1. Introduction

2. Brief

Building assessment of [REDACTED] based on a building report that identified earthquake damage to the subfloor. This damage is believed to be either 'missed damage', 'mis-scoped damage' or 'failed repairs' of which EQC are said to be responsible for.

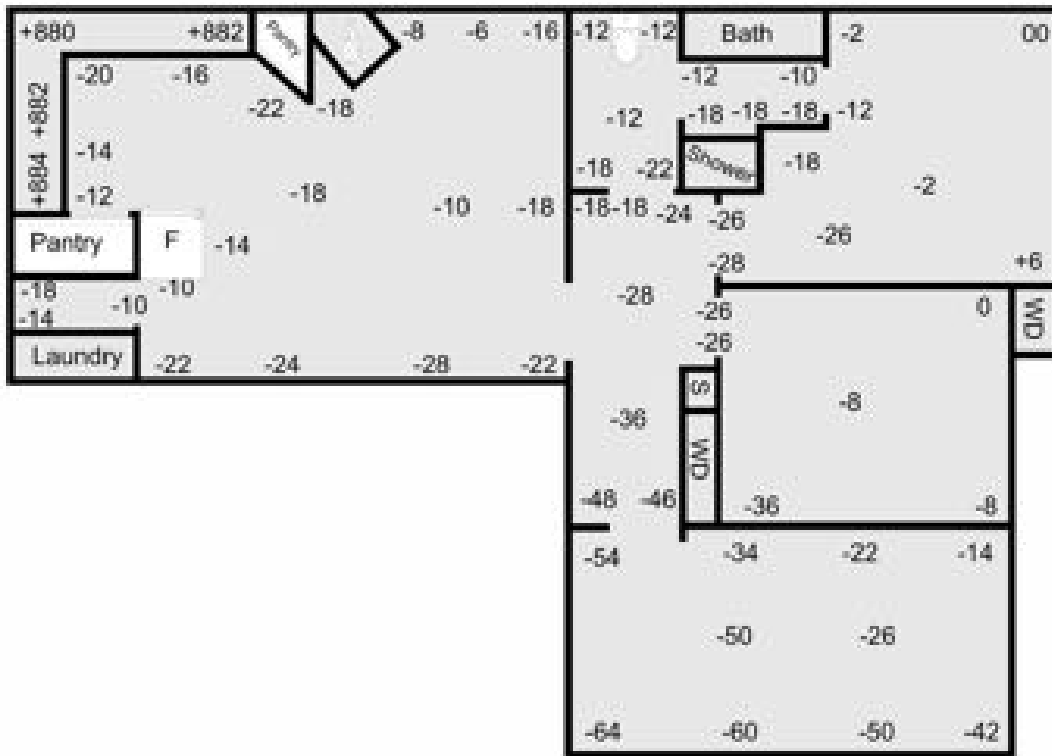
- 11 x failed repairs to piles
- 4 x failed repairs to subfloor framing
- 4 x missed damage to piles
- 9 x missed damage to concrete perimeter foundation
- 60mm max floor level deviation

Our recommendation is for EQC to engage a structural Engineer to conduct a Preliminary Structural Assessment to report on the Cavity Critter report. They should also conduct their site survey which will include a floor level survey and assessment of door & window sills, wall tilt etc.
